LINCOLN PARK PLANNING COMMISSION

Site Plan Review

Applicant	Reefer Peterbilt
Project	Retail (Truck Parts & Supplies)
Address	3535 Fort Street, Lincoln Park, MI 48146
Date	March 9, 2022
Request	Site Plan Review

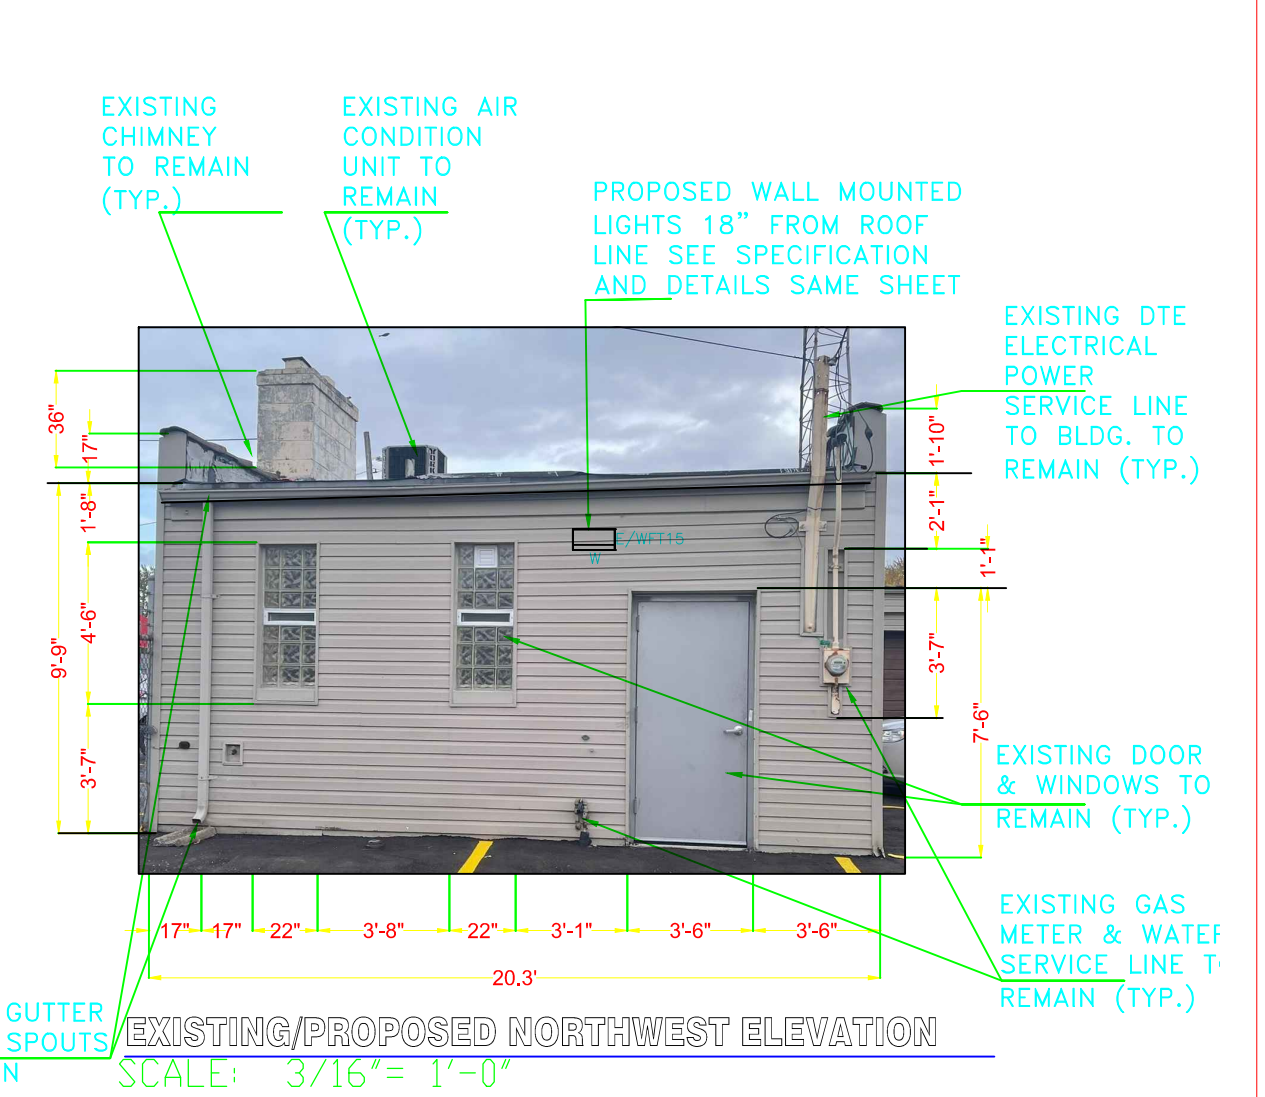
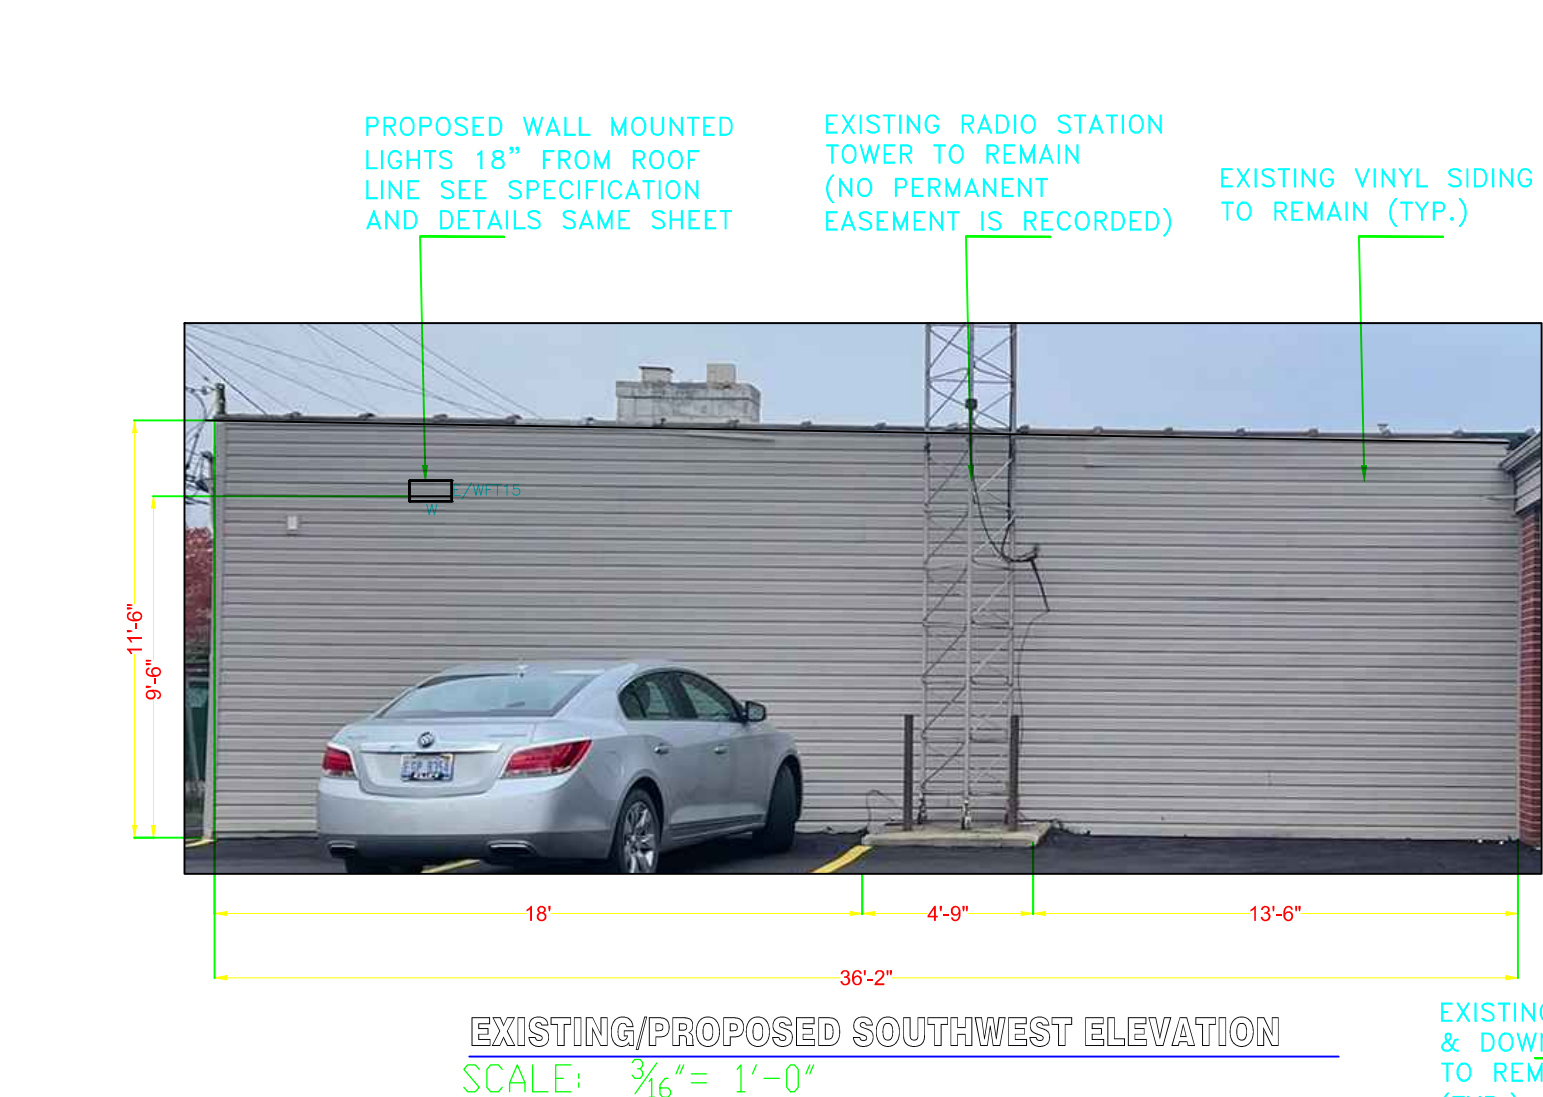
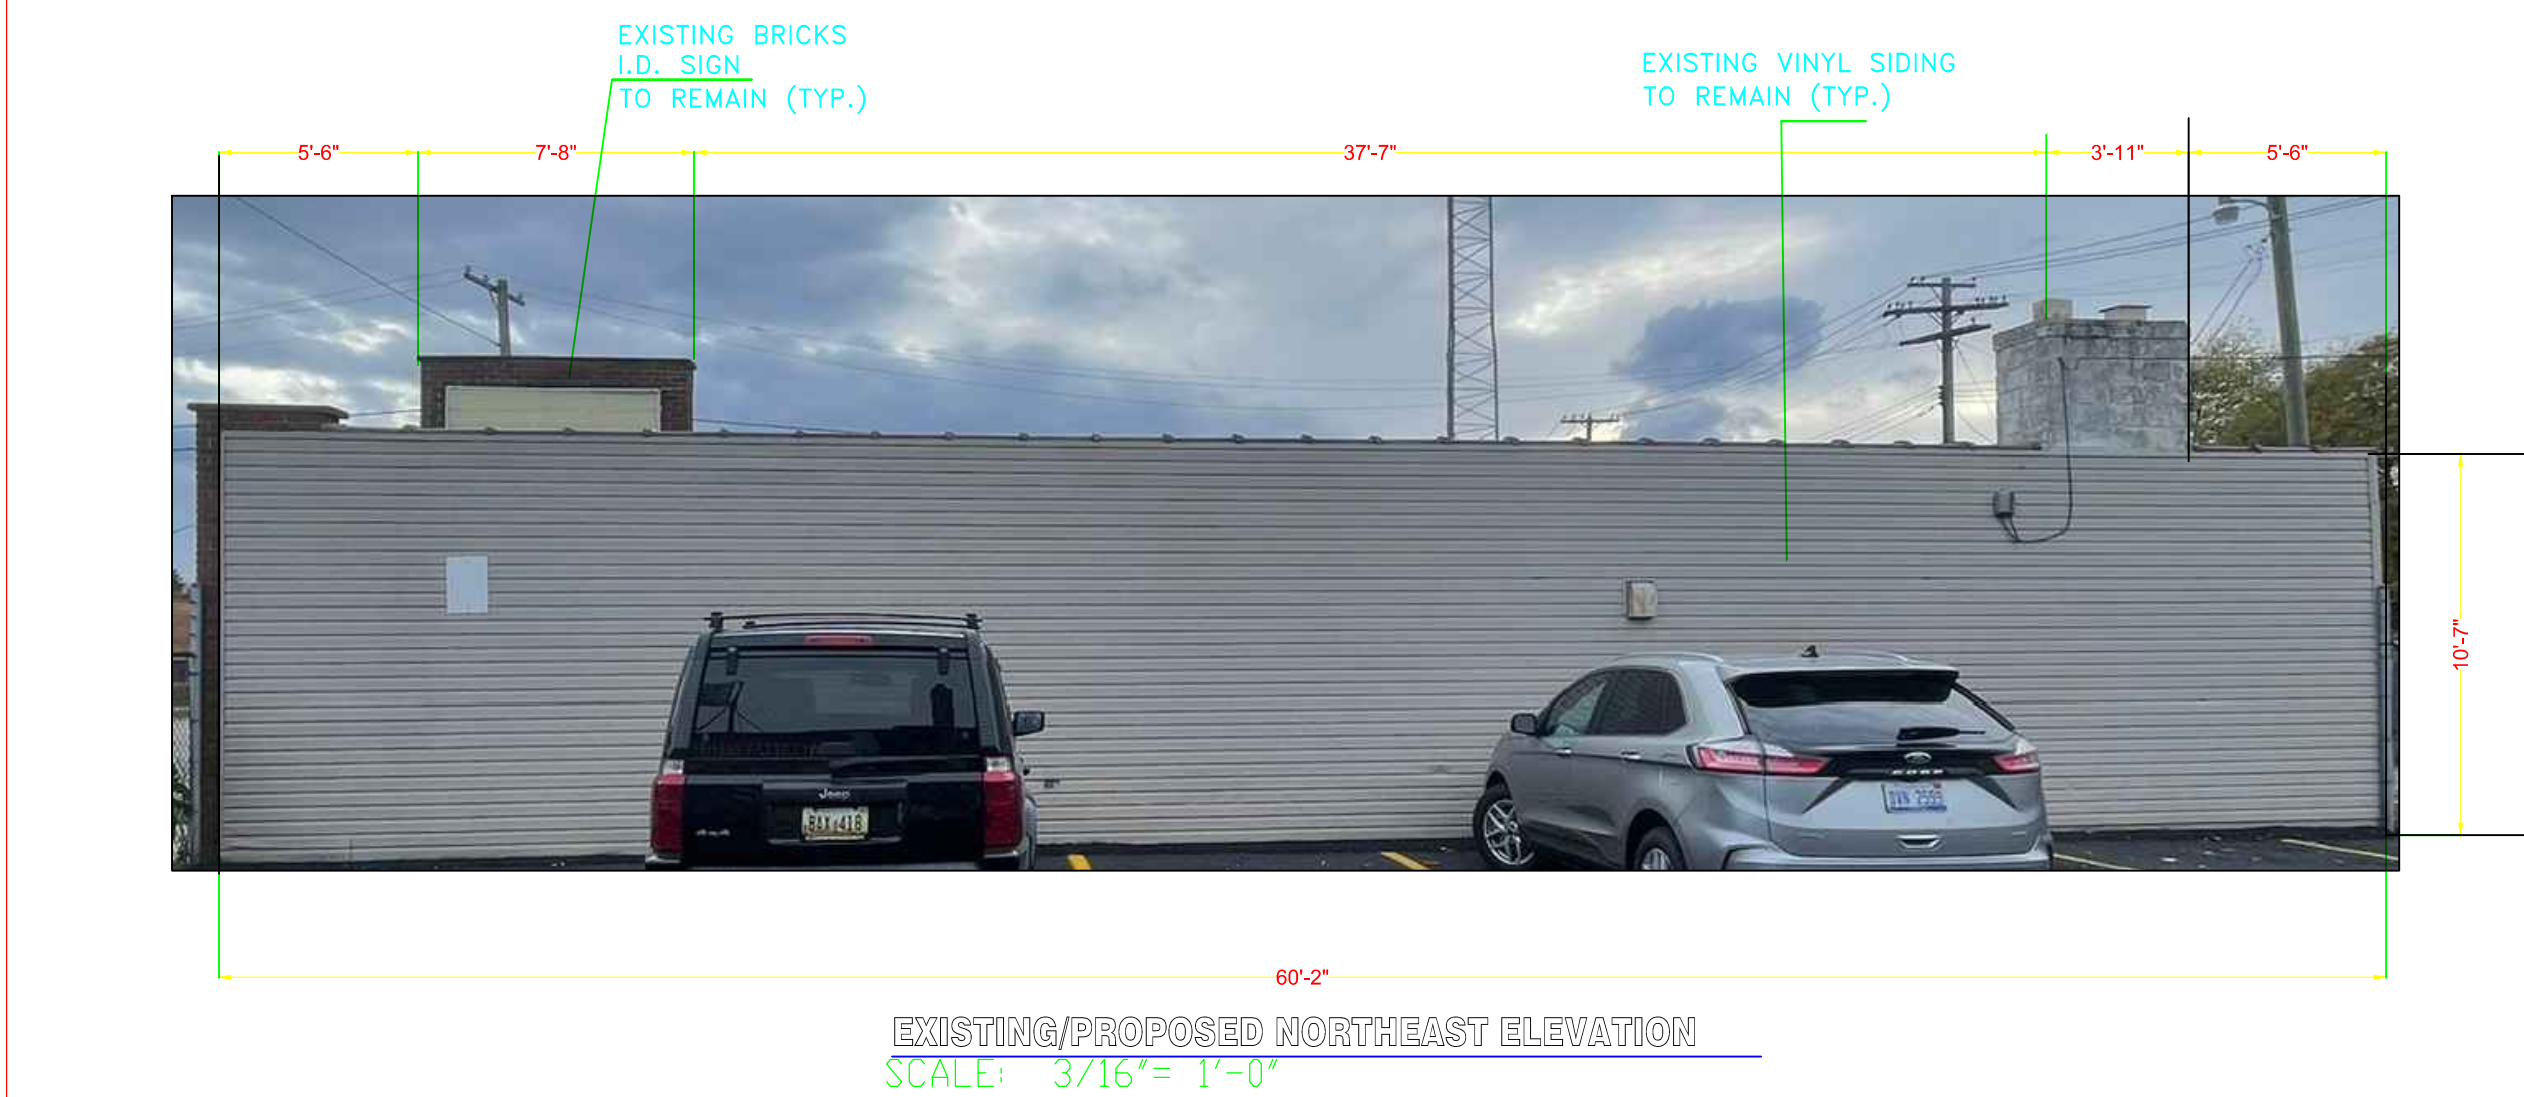
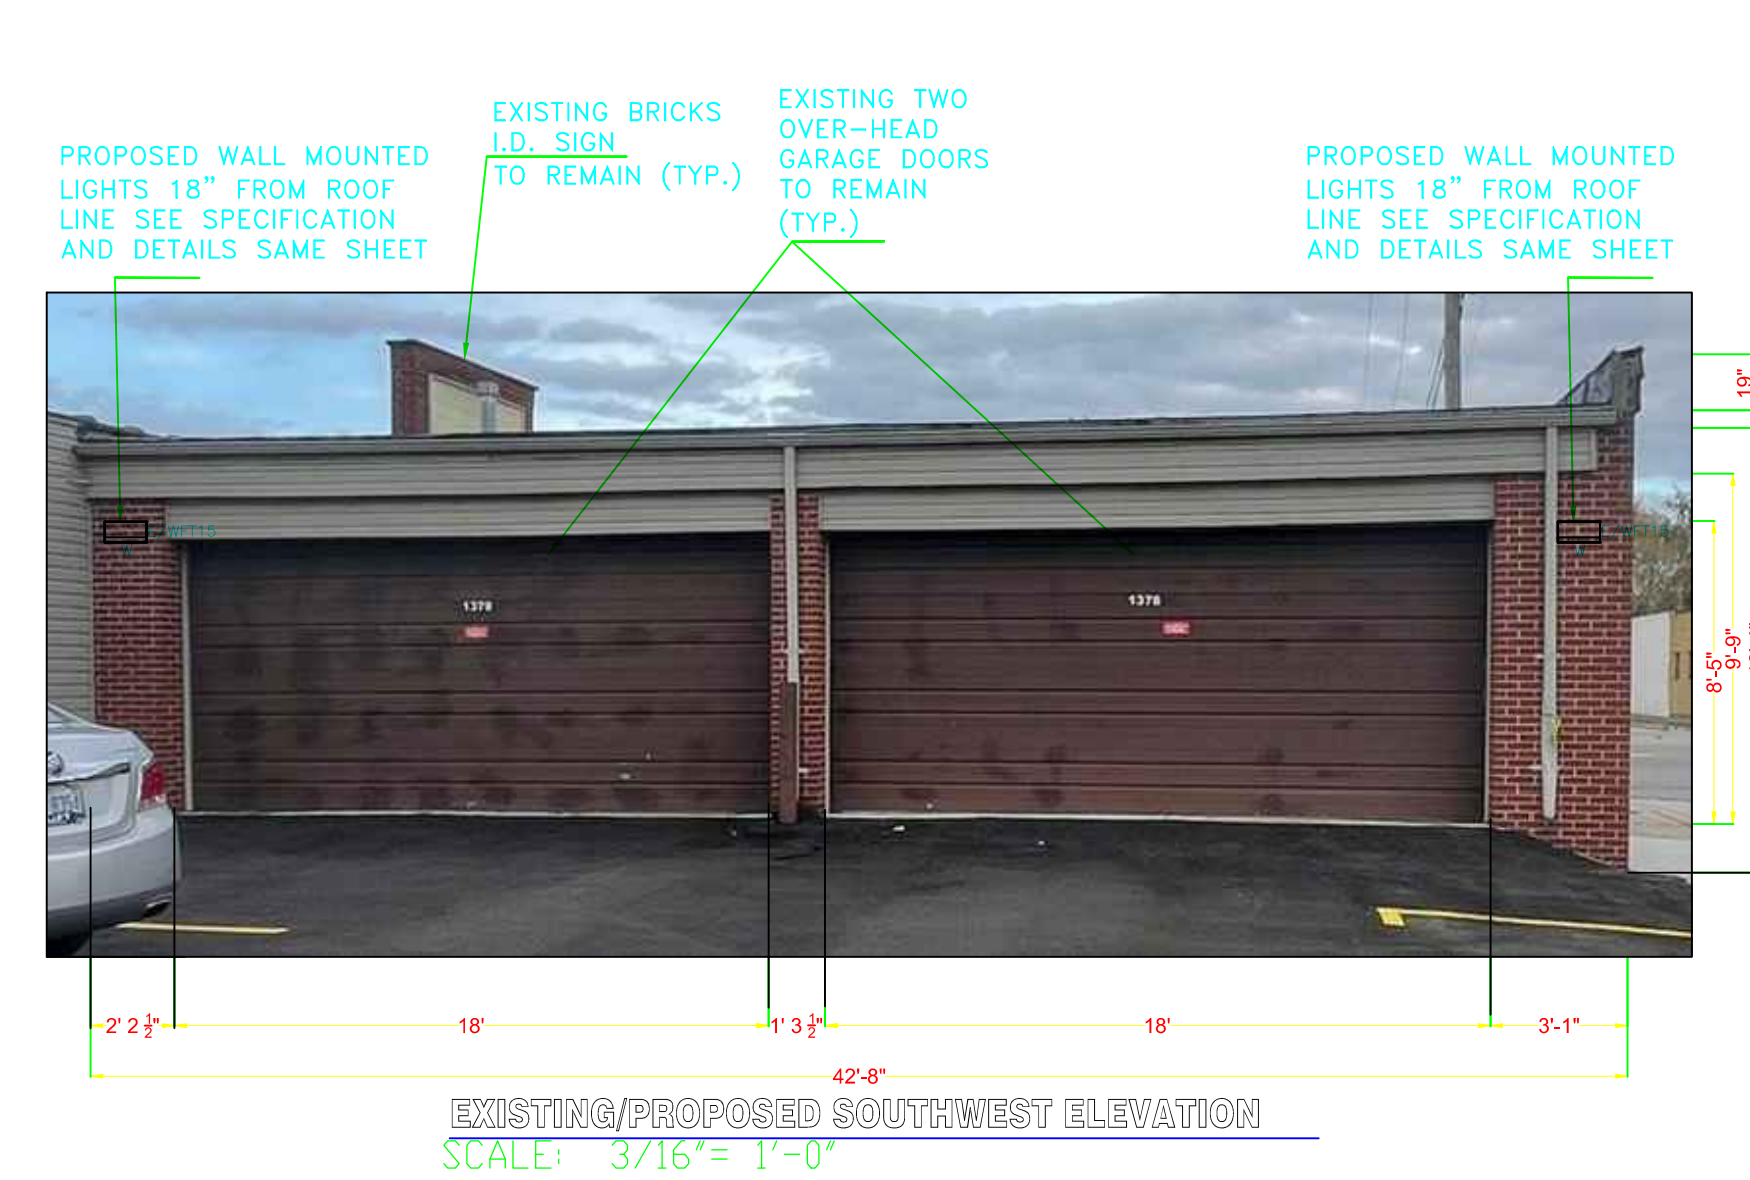
Eight (8) new wall-pack lights have been proposed to be placed on three sides of the building (facing each ROW and the alley). Specifications are shown on sheet CE4, elevations. Planning Commission to consider whether this style of lighting provides sufficient shielding to the residential use west of the site.
